Subject 404(q) letter

Action ID: AID 200110096

This letter is in reference to the Potash Corporation of Saskatchewan Phosphate Division, Aurora Operation (PCS) application for Department of the Army authorization to impact Waters of the US including streams and wetlands associated with a mine advance into a 15,100 acre project area surrounding its current mining operation located north of Aurora, Beaufort County, North Carolina. Additionally, please reference the Final Environmental Impact Statement (FEIS) released by the Corps May 22, 2008, and the Environmental Protection Agency's (EPA) July 23, 2008 comment letter on the FEIS and the proposed project. This letter responds to issues raised in EPA's July 23, 2008 letter, and is submitted in accordance with 404(q) 3(c)(3). It is my determination that, considering the recent modifications and the compensatory mitigation proposed, the project should not result in substantial adverse impacts to aquatic resources of national importance.

Modified Alt L - NCPC Proposed Impact Boundary 12/31/08
Biotic Communities Impacts and
Sandy Landing Road/NC 306 Relocation Impacts

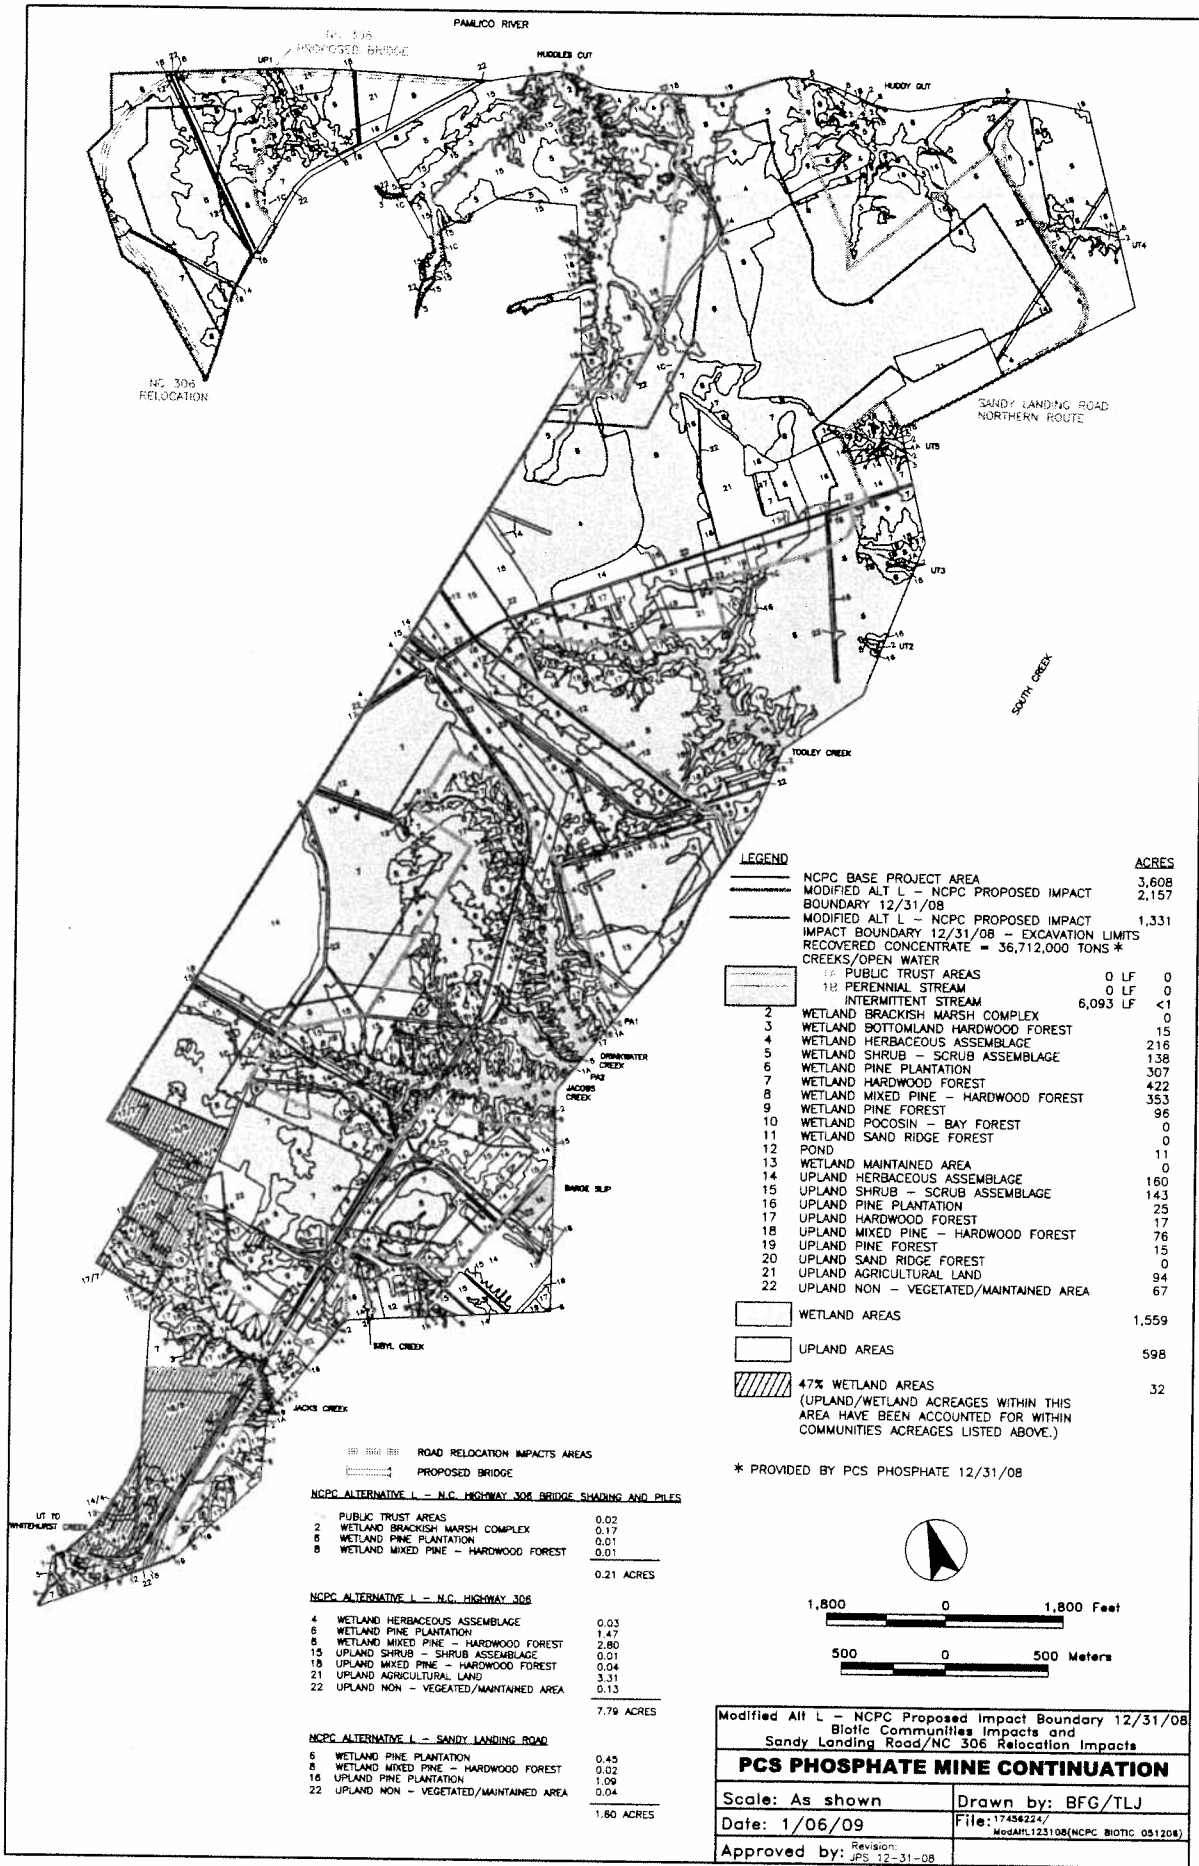
In its July 23, 2008 comment letter on the FEIS and proposed project, EPA stated that its primary concerns are with the “wetland and stream impacts to watersheds supporting the Albemarle Pamlico Estuary system over an extended timeframe, together with the cumulative impacts of ongoing mining.”

EPA further stated in its July 23, 2008 letter that although it finds S33AP the ‘environmentally preferable alternative,’ it prefers Alternative L from a NEPA perspective “since it avoids valuable wetland habitat, mainly on the NCPC Tract.” EPA did however, suggest that additional minimization of Alternative L be explored; particularly in the area of the Bonnerton Tract listed by the North Carolina Natural Heritage Program (NCNHP) as a Significant Natural Heritage Area (SNHA) of national importance. As presented in the FEIS, Alternative L avoided approximately 58 acres (21%) of the 271 acre SNHA. Through efforts led by the NCDWQ, Alternative L has been modified to now avoid approximately 174 acres (64%) of the area.

Based on these and similar comments, the Corps has worked with the applicant to further minimize impacts associated with Alternative L, as depicted in the Modified Alternative L Boundary maps dated January 6, 2009 (Enclosed). Within the NCPC Tract, the 3.79 acres of tidal palustrine forest identified as Essential Fish Habitat (EFH) at the headwater of Huddy Gut has been eliminated from the mine boundary, and additional minimization has also been accomplished in the headwaters of Tooley Creek. Further minimization has

Modified Alt L - Bonnerton Proposed Impact Boundary 12/31/08 - Biotic Communities Impacts	
PCS PHOSPHATE MINE CONTINUATION	
Scale: As shown	Drawn by: BFG
Date: 1/06/09	File: 17456224/MS09NLB09-123108(BIOTIC COM 030206)
Approved by:

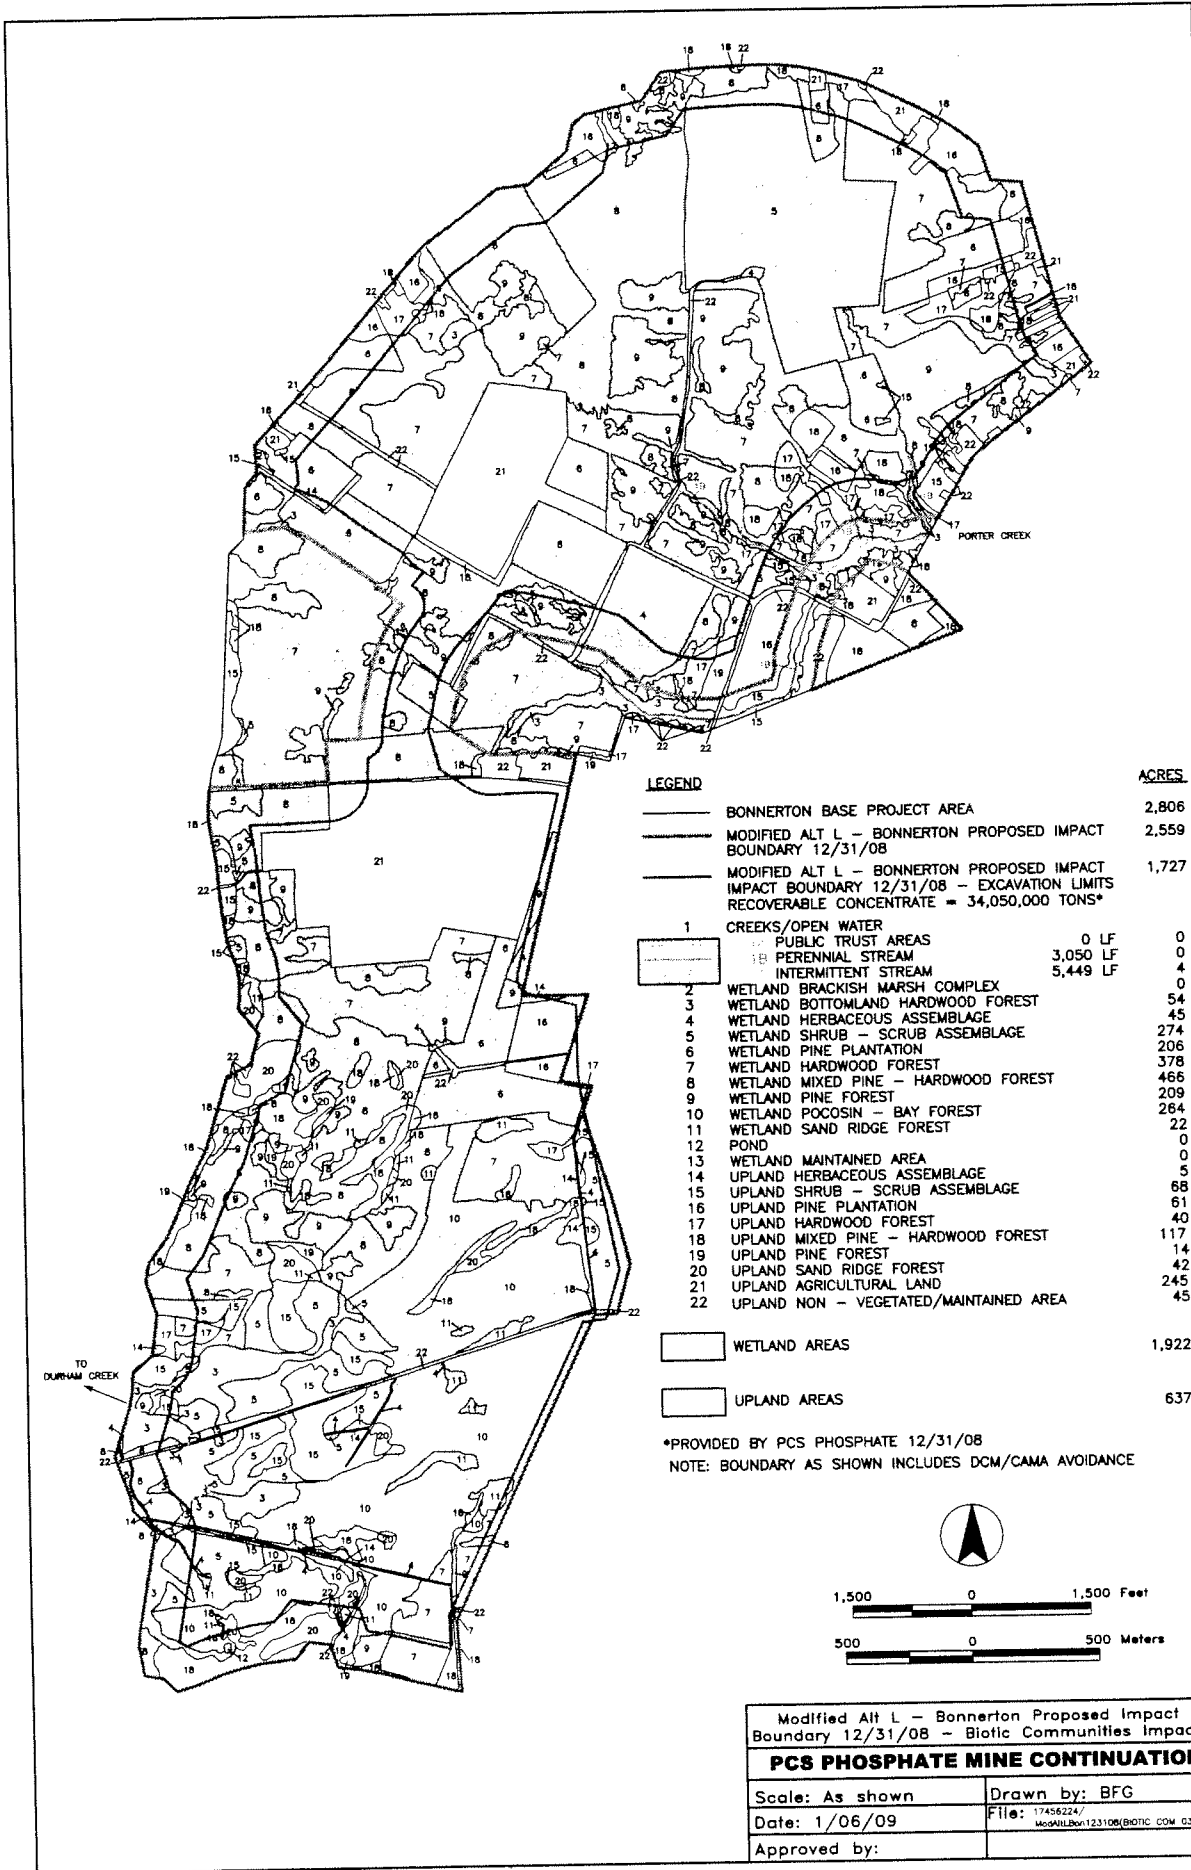
model” and new interpretation of economics. Finally, EPA raised concern over the level of impacts associated with Alternative L within the Bonneron and S33 Tracts. Much of this concern was focused on an area of hardwood wetland that was, at that time under consideration for listing by the North Carolina Natural Heritage Program as a Significant Natural Heritage Area of national importance. Responses to all specific comments included in this letter were fully addressed in the Corps’ response to this letter found in Appendix J of the FEIS.

been achieved in the areas buffering Broomfield Swamp and Cypress Run in S33 Tract and in the headwater area of Porter Creek in the Bonnerton Tract. In total, wetland impacts have been further minimized by approximately 158 acres. The modified Alternative L would allow mining and mine related activities to occur within approximately 11,454 acres, including 7,482 acres of uplands and 3,972 acres of wetland habitats over a period of approximately 37 years. While this activity will result in the long-term alteration and, in some cases, permanent loss of wetland and upland wildlife habitat within the mined footprint, the avoidance and minimization efforts incorporated into Alternative L will result in the maintenance of upland and wetland wildlife corridors along the Pamlico River, South Creek, Durham Creek and their tributaries.

Modified Alt L - South of 33 Proposed Impact Boundary 12/31/08 - Biotic Communities Impacts

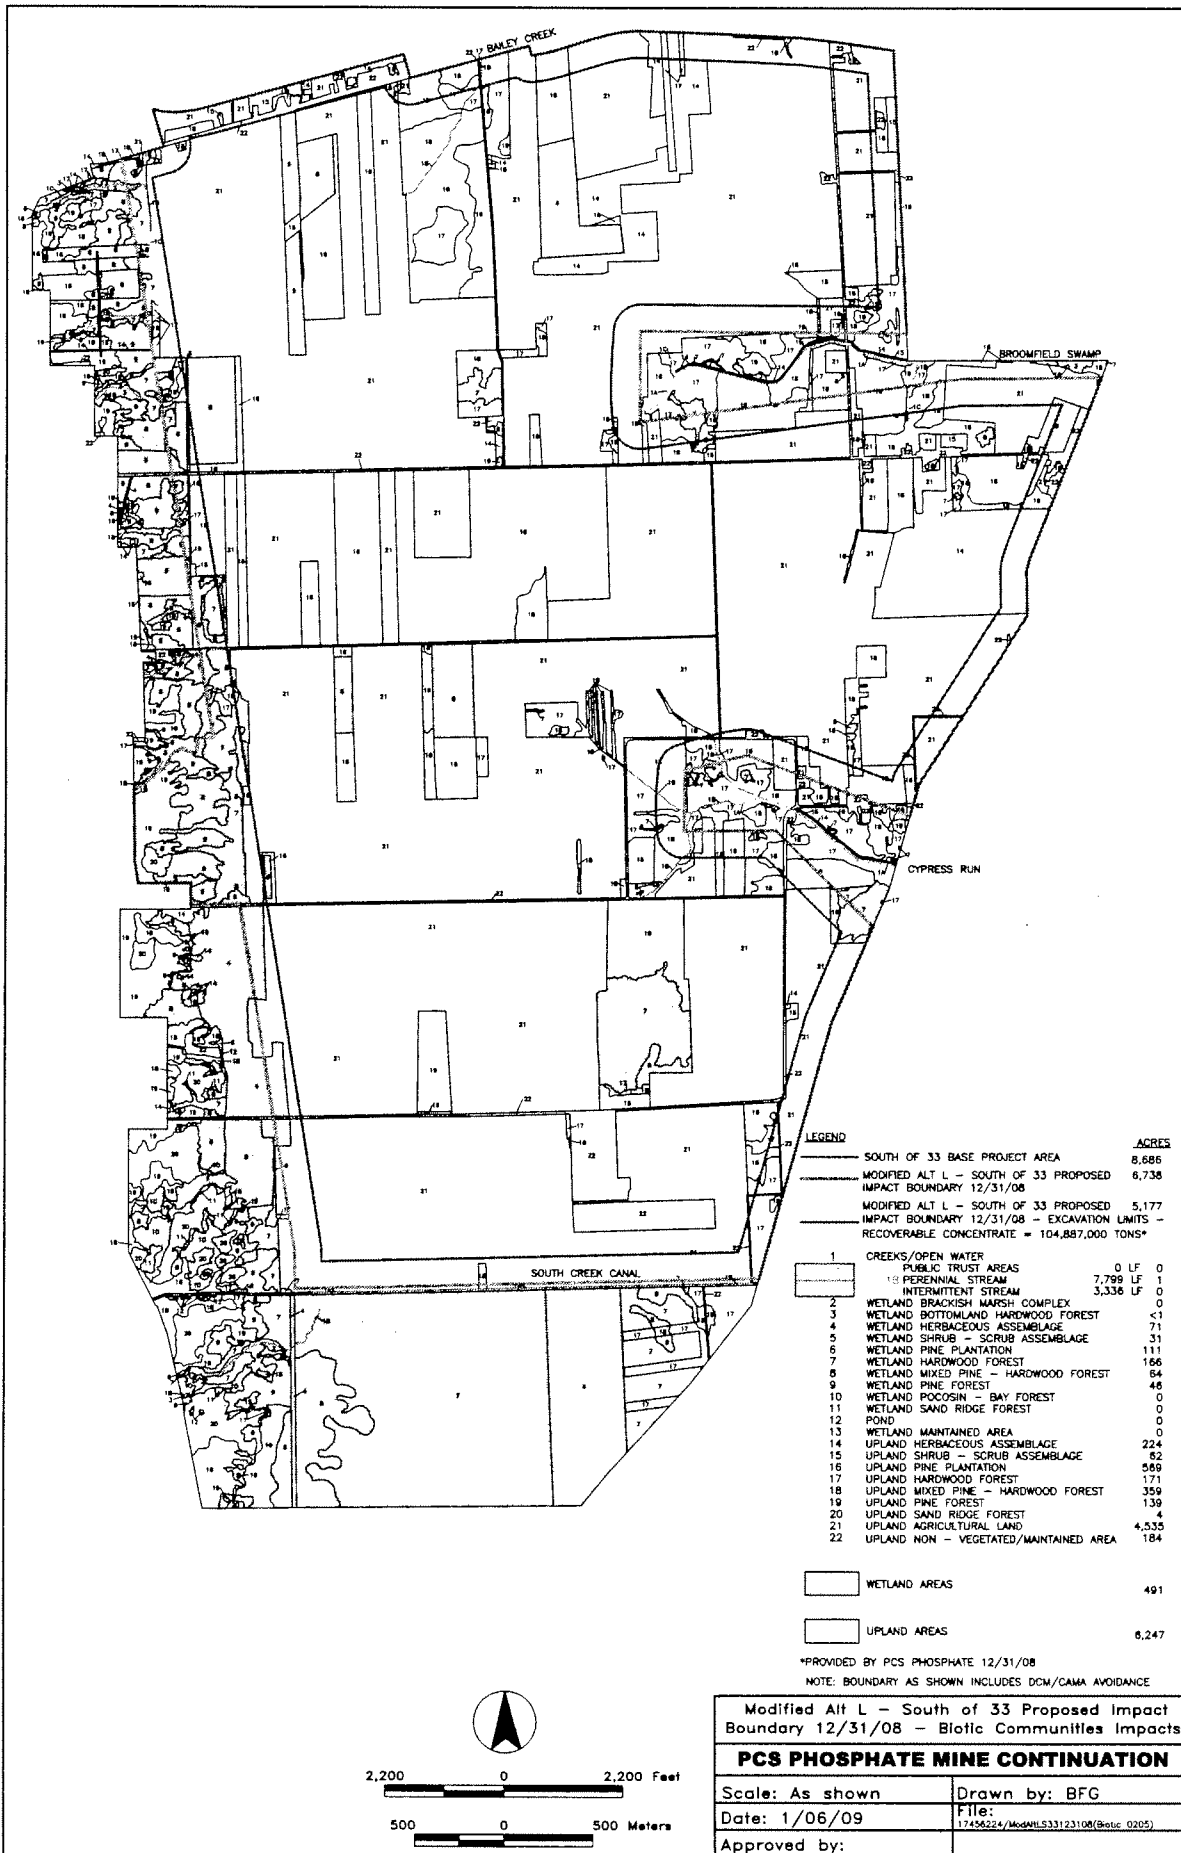
Finally, EPA suggested modifying the Alternative L boundary presented in the FEIS by adopting the boundary used in the SCRA alternative on the S33 Tract. EPA found that this would reduce impacts by approximately 38 acres of wetland and 10,167 linear feet of stream. The Corps has worked with the applicant to further minimize the impacts of

Alternative L on the S33 Tract. This modification has resulted in avoidance of approximately 19 acres of wetland and 3,227 linear feet of stream. This additional minimization has increased the buffer area around Broomfield Swamp and Cypress Run. The majority of the wetland area and streams remaining in the impacted area of the S33 Tract are of reduced value and further avoidance would result in loss of mineable resource with no substantial change in overall impact of the Alternative.
